Title: New Synthetic Oil for Eaton and Spicer Transmissions

Applies To: Eaton and Spicer Starting 04/01/2006

[TSI Number: 06-13-03](#)

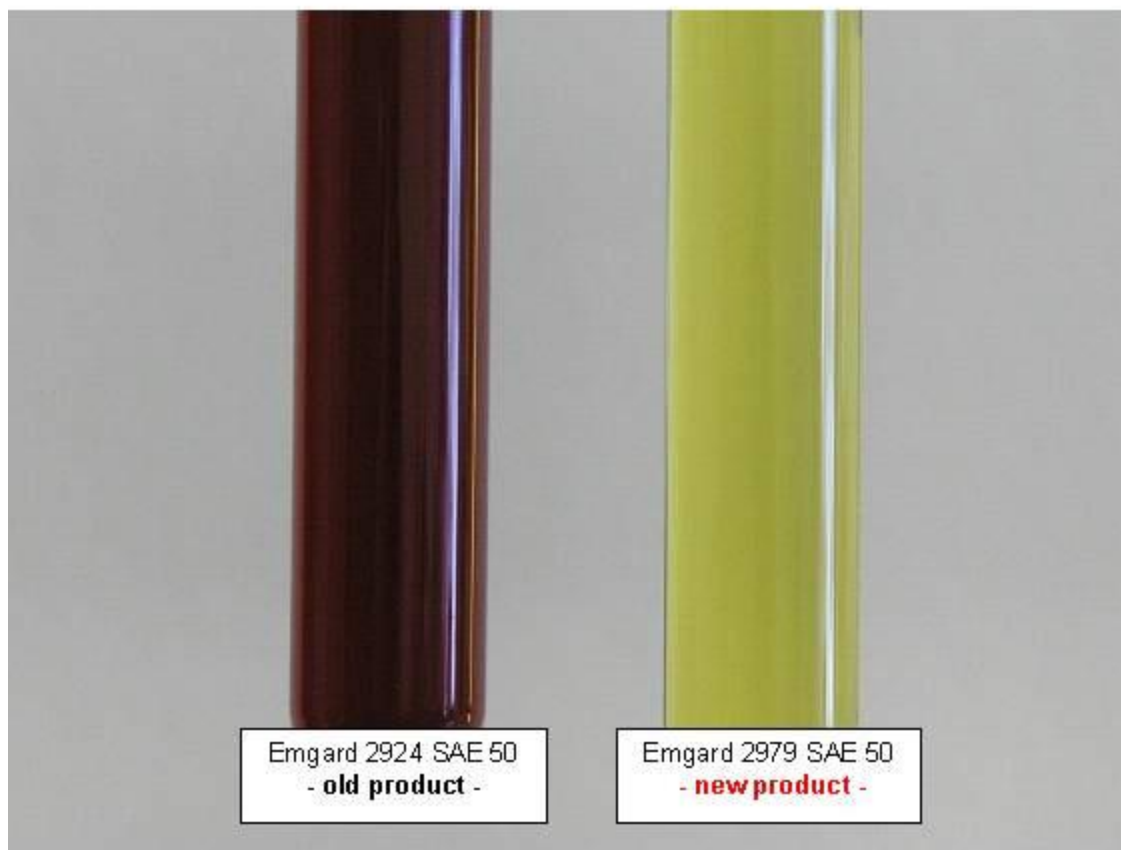
A color is not specified in Eaton ® 's PS-164 Rev 7. Cognis chose to maintain the natural color for the new MTF, which is Amber (please refer to color chart below).
